RE: Remarkables Ski Area Upgrades and Doolans Expansion - Response to Natural Hazards Feedback

Re: Natural Hazards Assessment Peer Review, Remarkables Ski Area Expansion

Reference: Responses to Questions on Doolans Natural Hazards Assessment

Figure 8. ORC Hazard Maps - Landslides

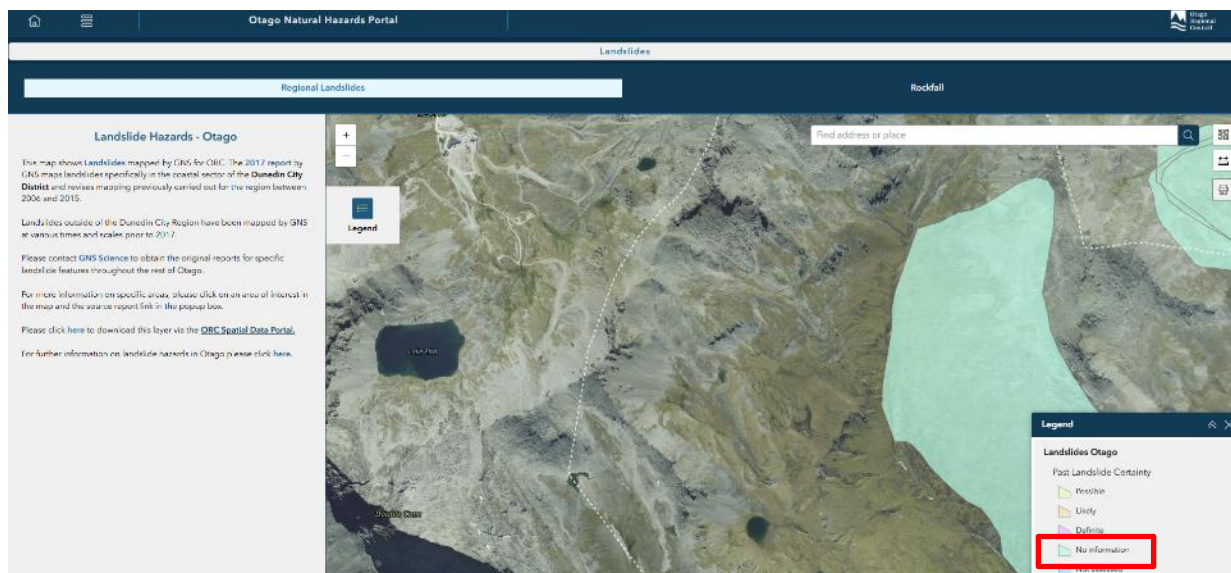
"I am in general agreement with the findings but note that the true left bank and face above is mapped as Landslide on the ORC natural hazard portal. Does this feature require a more specific assessment to better inform the risk assessment?"

N.B the true left of the Right Branch is identified as a potential landslip but with 'no information'

The risk to proposed infrastructure associated with the development is low as there are no elements of the development proposed to be within this area. The slope is shown below.

We consider that the risk of large-scale land instability resulting in a dam in the creek and potential dam break, leading to a Debris Flow to be low as no signs of recent large scale land movement have been detected.

We consider that a potential risk is local slip failure of the True Left bank of the stream in an area which is over steepened and deeply incised by Doolans Creek Right Branch. This risk is identified in the Natural Hazards report (as below) and is considered to be a low natural hazard risk. This low risk would be further mitigated by the following factors;

Figure 13. Stormwater flow diagram for overflow of the Rastus Burn Creek

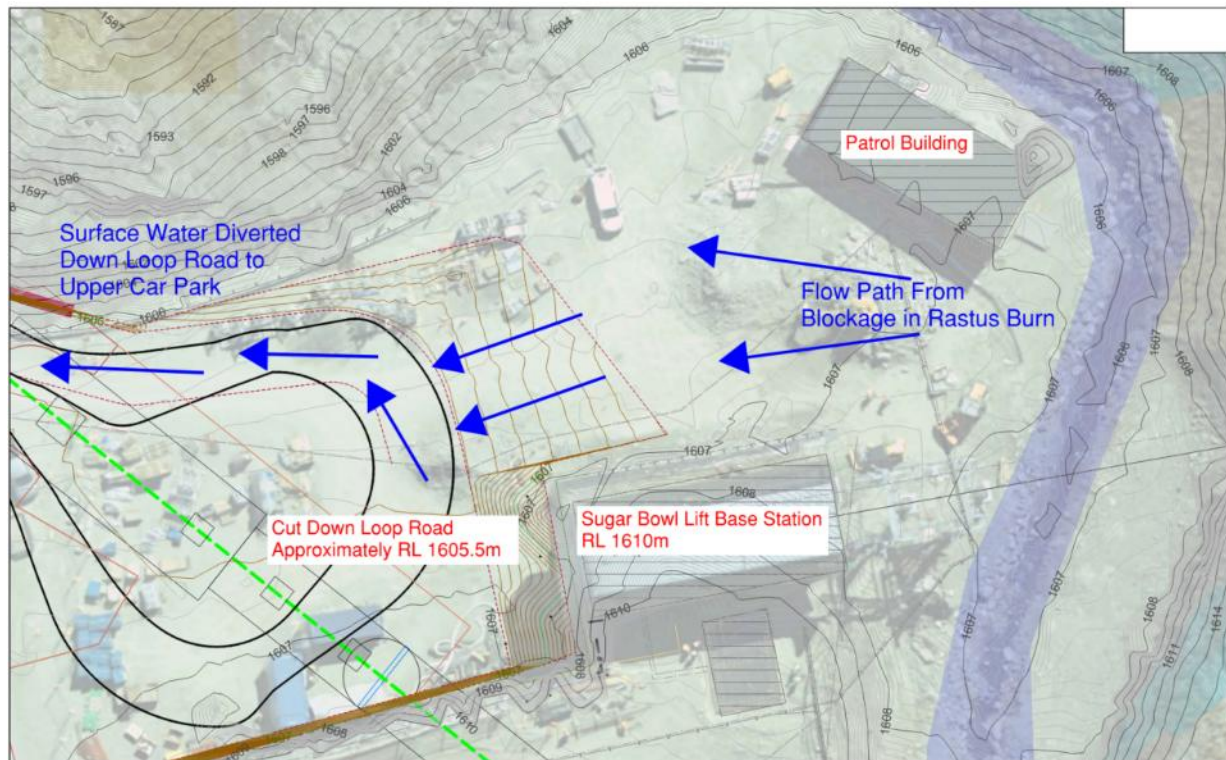
"Gondola Base Station and Base Building Flood risk - Noting this is within the QLDC boundaries. No detailed information has been provided in relation to the SW modelling that informed the design. Were any blockage factors applied in the assessment of the channel capacity."

The Gondola Base station is at the first-floor level of the Base Building. The area beneath the Gondola Base Station, in the 'drop off area' will be cut down by approximately 1.5m to form a loop road for bus and vehicle access to turn around beneath the Gondola Base Station. The Loop Road surface will be 1.5m approximately below building ground floor level. Thus, in the event that there was significant a blockage in the Rastus Burn adjacent to the Patrol Building, it is possible that water could spill out of the channel between the Patrol Building and the Sugar Bowl Lift Base Station onto the Drop Off Area surface. This water would flow down the cut slope and onto the loop road formation which acts as a Secondary Flow Path. This water would then flow down the road and would not be able to enter the base building as the road level is approximately 1.5m below ground floor level in the Base Building. This is shown in the diagram below:

Figure 16. Contour plan of Gondola Return Station Area

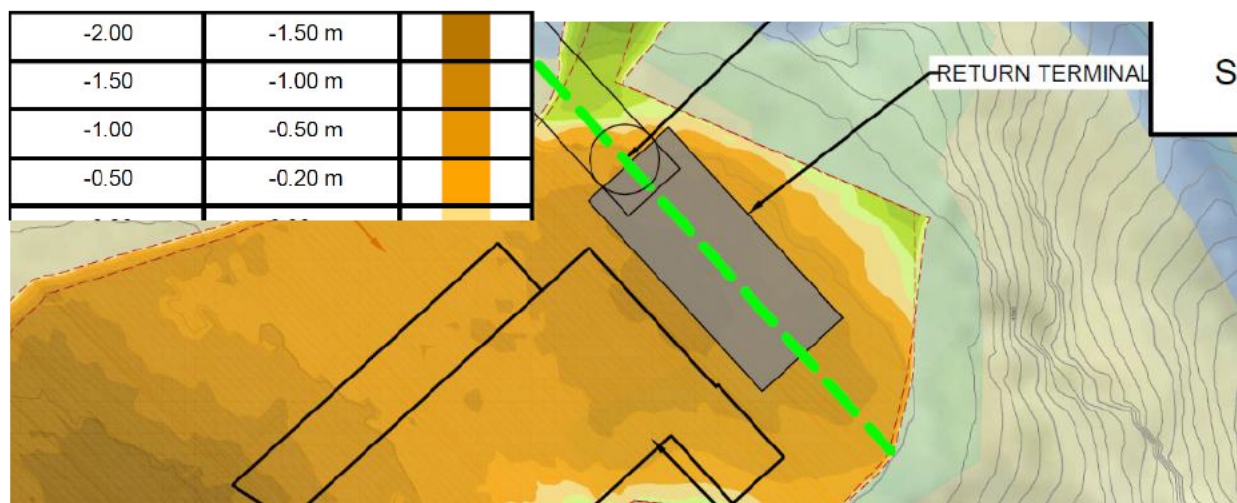
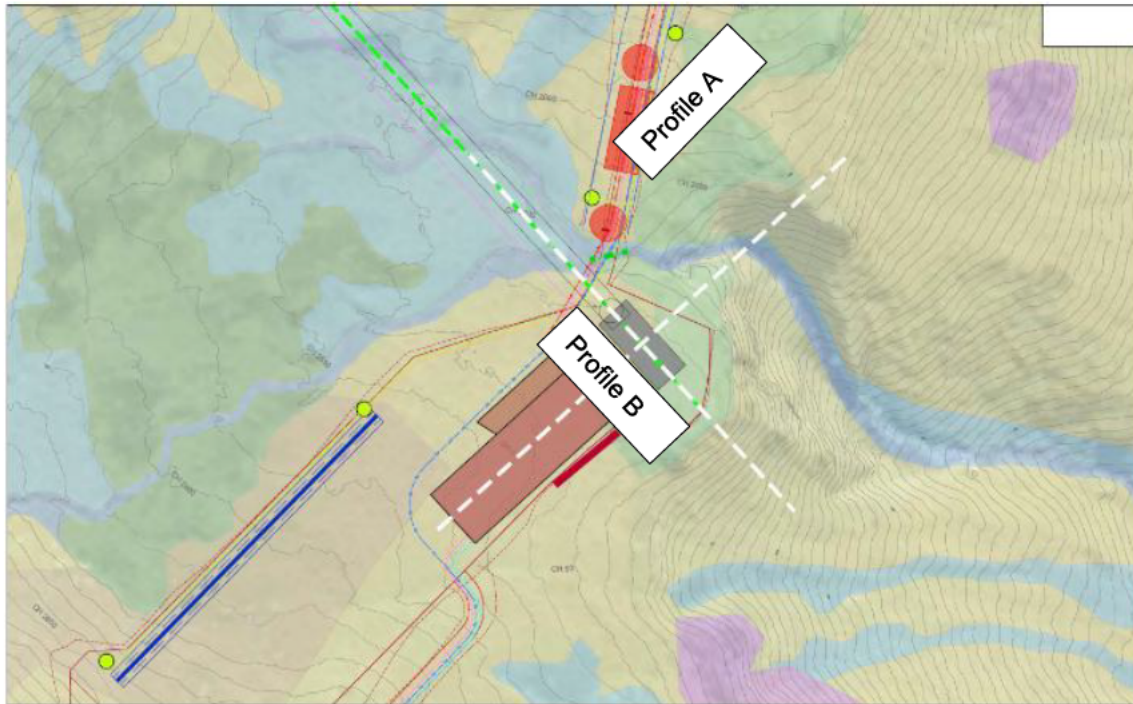
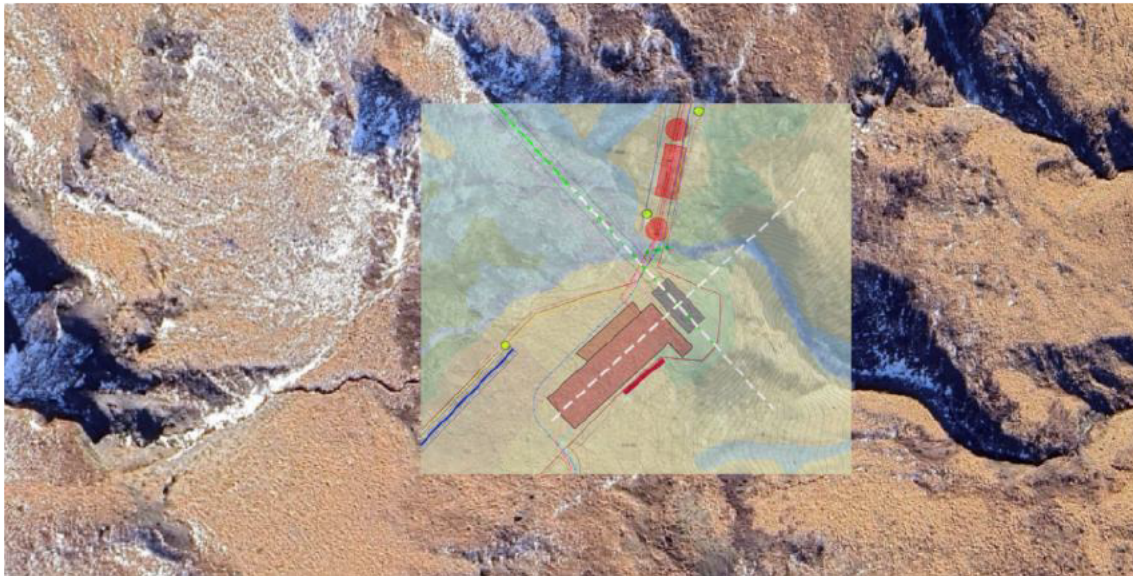
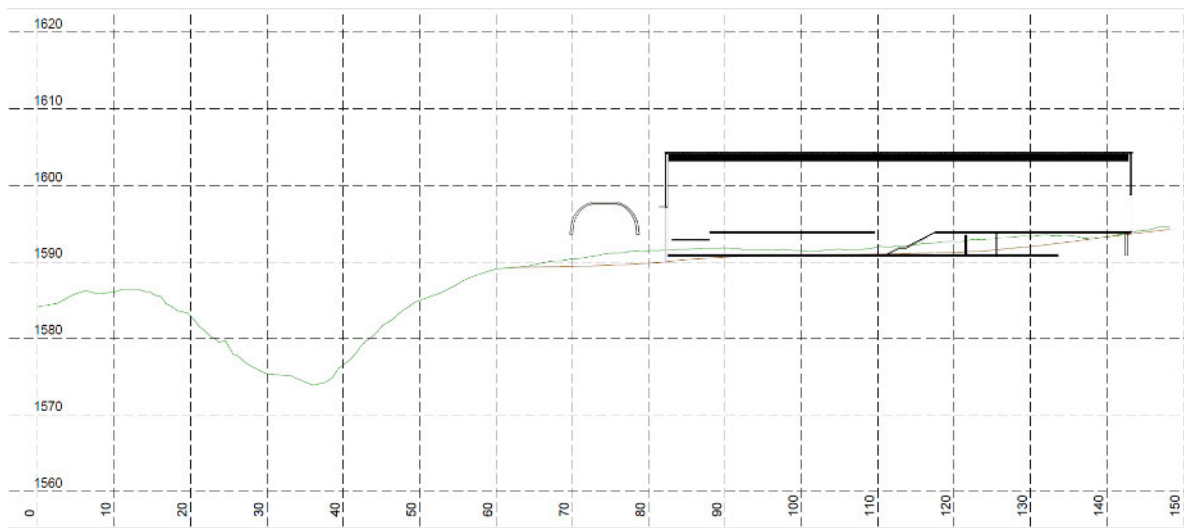
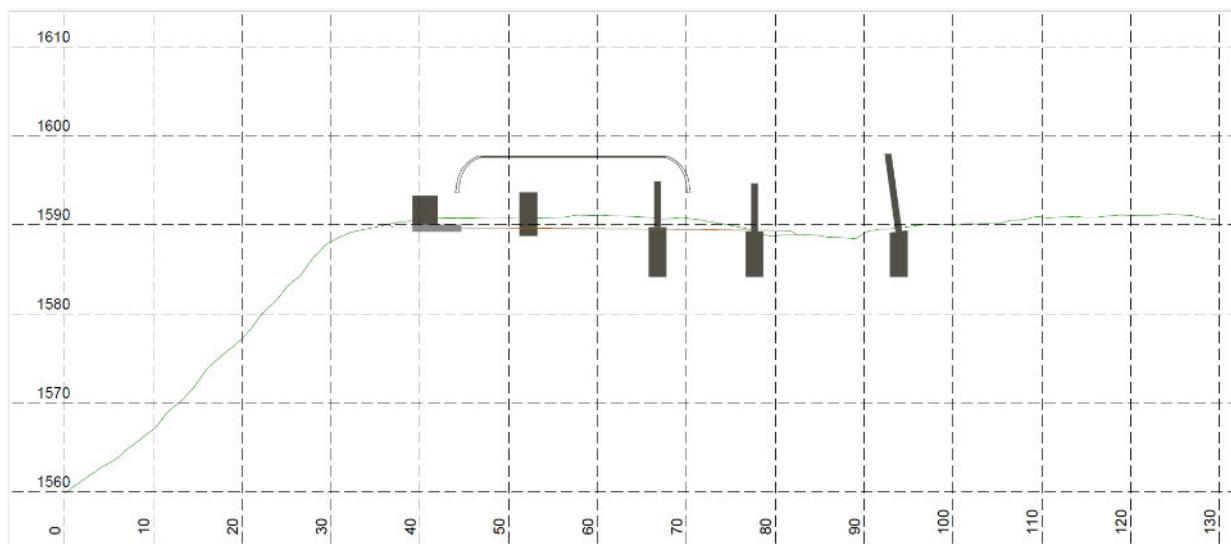
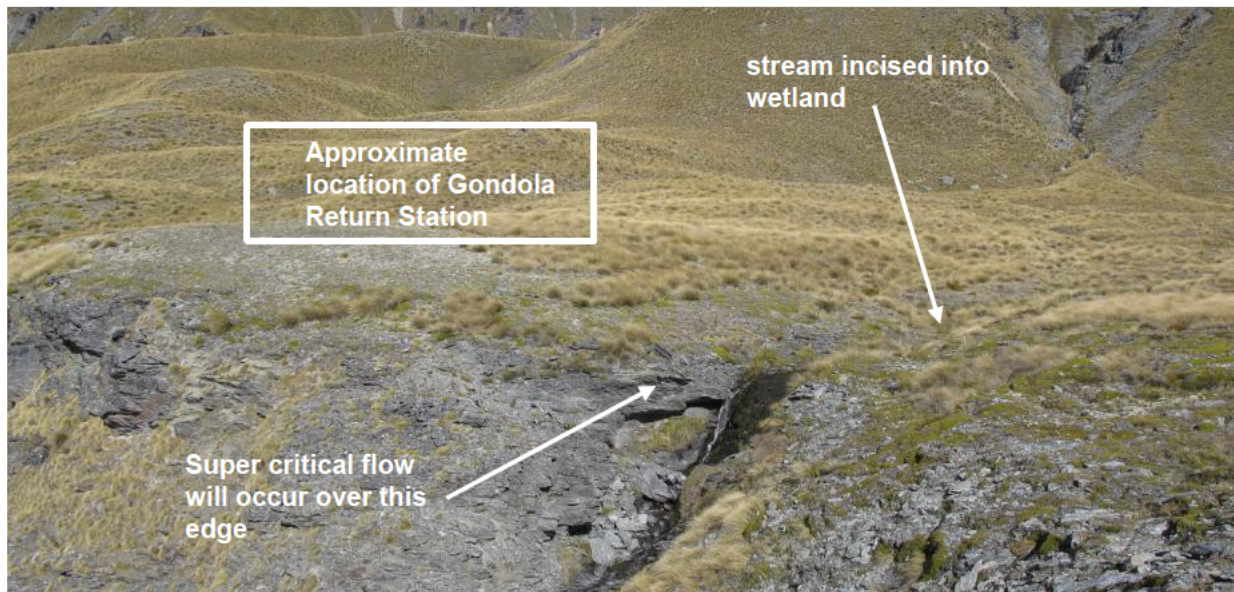
"The return base area has been located on a rock knoll and the report comments that there is 5m height difference between the gondola station and the adjacent overland flowpath. Development plans show the ground under the return base being cut down some 2.5 to 3m. Does the 5m height difference reported allow for this cut down?"

We are confident, based on initial site investigations, that there is sufficient hydraulic capacity in the channel available to drain stormwater from the wetland adjacent to the Gondola Return Station without risk of inundation of the Gondola Return Station in a design level event.

The level of ground cut down at the location of the Gondola Return Station is only a maximum of approximately .1.5m.

Sections through the Doolans Gondola Return Station have been prepared along the lines on the figure below to demonstrate the area of channel to drain the wetland adjacent to the Gondola Return Station. The contour interval is 2m in the contour view below.

- The level difference between the platform level and the riverbed to the north-east is approximately 16m as shown in Profile A
- The level difference between the platform level and the riverbed to the north is 2m
- The level difference between the finished platform level and the wetland to the north-west is approximately 0.5m as shown in profile B

While detailed design remains to be completed, for stormwater ponding in the wetland to reach the level of the ground at the Gondola Return Station, a channel up to approximately 2m deep and approximately 25m wide with significant gradient would need to be flowing at the outlet to the wetland adjacent to the Gondola Return Station. We anticipate super critical flow will occur in the channel downstream of the Gondola Return Station. Thus, there is significant hydrological capacity available to drain the wetland before the water level in the wetland reaches the level of the Gondola Return Station. This will need to be confirmed as part of Detailed Design.

Figure 25. Section through proposed reservoir from Reservoir Concept Report

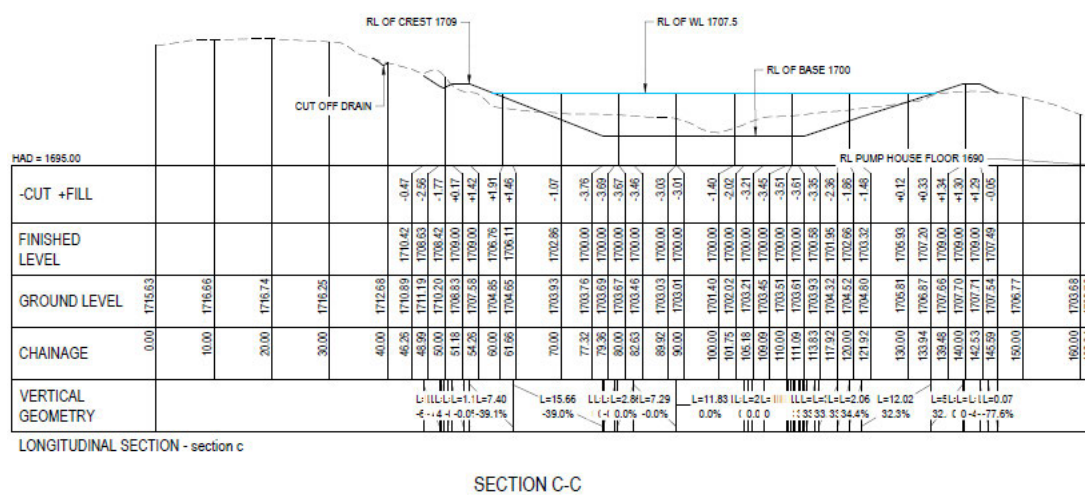
"Has an assessment of the reservoir site been undertaken to ensure that the site is stable and suitable to establish a reservoir? Typically subsurface investigations would be carried out to better ascertain ground conditions - drilled borehole.

The Stantec report references the NZSOLD guidance for the detailed design of the reservoir. This guidance also includes a recommended approach to establishing the Potential Impact Classification (PIC) of the Dam and provides a risk assessment methodology for proposed Dams. Has a PIC assessment been undertaken for this Dam? Has Stantec considered using the NZSOLD risk assessment methodology in place of the baseline NPSNH methodology? My review of the Draft plans provided suggest that the reservoir will be formed entirely in cut with only minor filling being undertaken to achieve freeboard, but please confirm.

With consideration of the above are Stantec satisfied that the investigations to date are sufficient to confirm that the reservoir location proposed is viable?"

A separate concept report for the reservoir site has been prepared, and we understand that this will be forwarded separately to Mr Cruden. In relation to the reservoir site, we note the following;

- The reservoir will be designed in accordance with the NZSOLD guidelines
- The reservoir is largely in cut and the outlet from the reservoir will be by pumping out, thus avoiding the necessity for a cut through the reservoir wall and as a result the reservoir will not be a Large and Classifiable Dam.
- Investigations to confirm the underlying ground conditions, including the rock depth and ground water level, will be undertaken when access to site for suitable plant is possible.

We have not identified issues which would preclude the use of the proposed reservoir location and consider the investigations to date are sufficient to confirm the proposed reservoir location is viable, but we agree with Mr Cruden the need to undertake specific investigation of the site prior to construction to confirm its suitability.

An approximate east-west cross section, taken from the Reservoir Concept Report, is reproduced in the figure below. This demonstrates that the reservoir is largely constructed into the existing slope and does not have significant embankments.

Figure 27. Department of Conservation Natural Hazard Risk Thresholds for Visitor Sites, likely potential status of the road above Swan Lake marked with circle

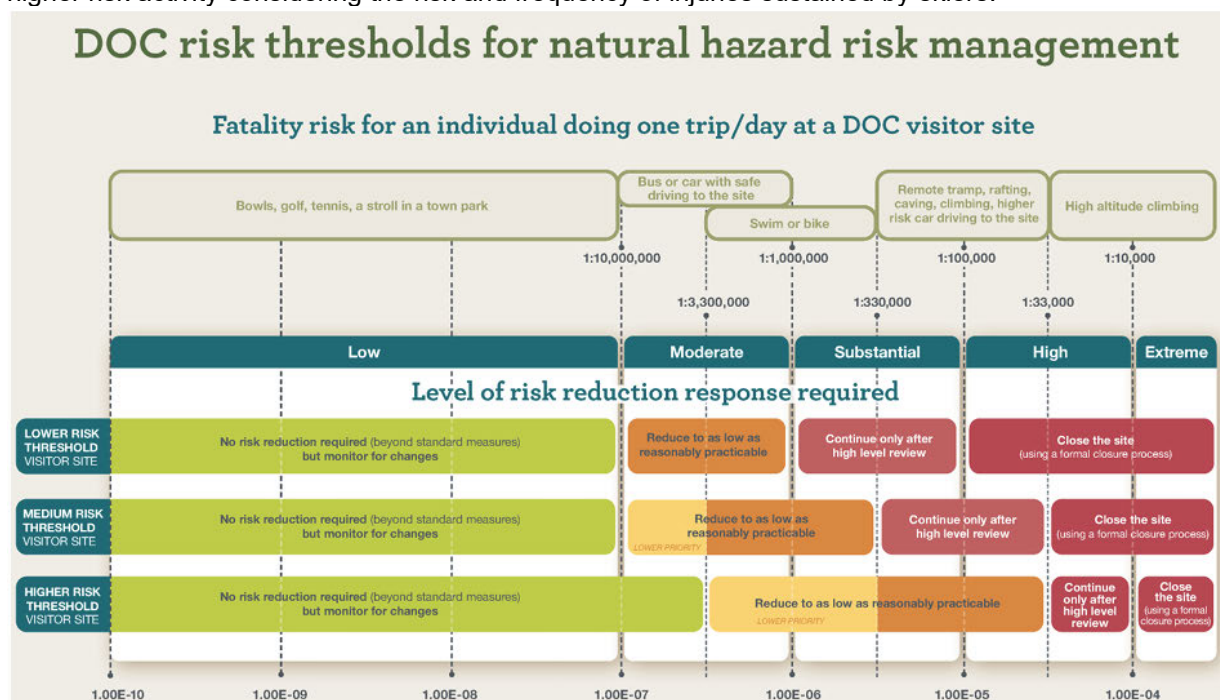
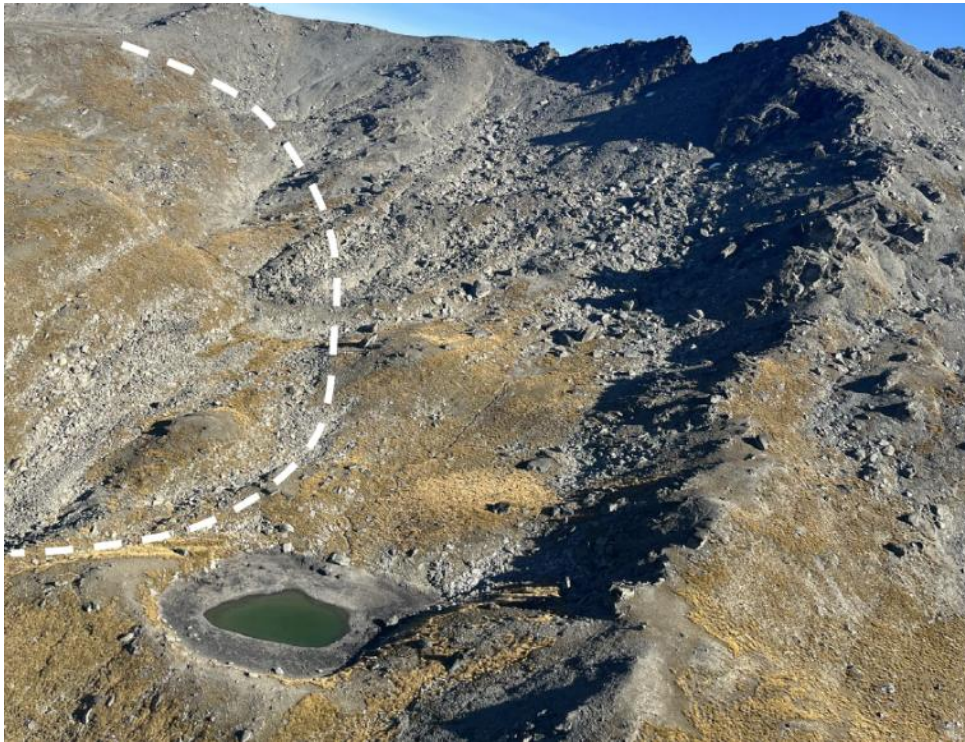
The NPSNH Explanatory note clarifies that the policy provides a baseline only and permits more detailed alternatives. The NZGS Slope Stability Geotechnical Guidance Series Unit 1 (2024) represents best practice in this area. It provides detailed semi quantitative and qualitative approaches to estimating landslide, and specifically rock fall hazard. This is covered in sections 6 and 12 of the NZGS guidance. Recommended methods included in the NZGS guidance include the "AGS Guideline for Landslide Susceptibility, Hazard and Risk Zoning 2007" approach and the "Department of Conservation Guidelines for Natural Hazard Risk Analysis (2020)" approach. The latter may be of particular relevance in this instance given DOC's interest in the site."

We concur with the response from Mr Cruden regarding the rockfall risk in the area above Swan Lake on the northwest side of Helicopter Ridge.

Remarkables Ski Area has been operating for more than 40 years and we are not aware of recorded significant rockfall in this area over the time of operation. Irrespective of the rockfall frequency being 20-50 years or 50-100 years, the NPSNH identifies this risk as 'High' for both periods where the consequences are 'Major'.

The Department of Conservation risk thresholds for Natural Hazards are shown in the figure below. It is considered that there is a 'Higher risk threshold' for this site and activity and that mitigation measures such as operational rules and the practicalities of winter and spring operation will reduce or eliminate the use of the road at higher risk times. The Departments guidance is that 'higher risk' activities include tramping tracks, routes and grade 5 and 6 cycle trails. Thus, off-piste skiing could be considered a higher risk activity considering the risk and frequency of injuries sustained by skiers.

Rockfall from the ridge adjacent to the proposed reservoir, which is oriented north-west to south-east, is less than the rockfall risk from Helicopter Ridge in the area above Swan Lake. This is because the ridge adjacent to the reservoir has fewer potentially unstable rocks and has a more benign slope below. In addition, formed and groomed ski trails are located outside any likely rockfall runout zone. The area between the ski trails and the ridge line, up slope of the Reservoir, will not be groomed but will be opened for off-piste skiing when snow conditions allow. This physical separation between the groomed trails and the ridgeline is indicated in the Natural Hazards Report. The area between the ski trails and the ridge and the area will be skiable, off-piste, terrain. Off Piste skiing is clearly a higher risk threshold visitor activity and is likely only to be undertaken by competent skiers. Skiing in the area above the reservoir is a moderate risk activity, per the Department of Conservation figure above, and the number of skiers in this location is not expected to be high and the presence of skiers within this area is transitory. The road and trail route in relation to the ridge is shown in the figure below from the Natural Hazards Report.

If rockfall occurs during the ski season rockfall energy will be attenuated by the presence of snow, although this effect is variable depending on the snow conditions and is thus not able to be accurately quantified. Overall, the natural hazard risk from rockfall above the reservoir is considered to be mitigated for the reasons set out above and is considered to be an acceptable level of risk for an activity occurring within an alpine environment. This level of risk is consistent with the level of risk associated with off piste skiing on commercial ski areas in New Zealand.
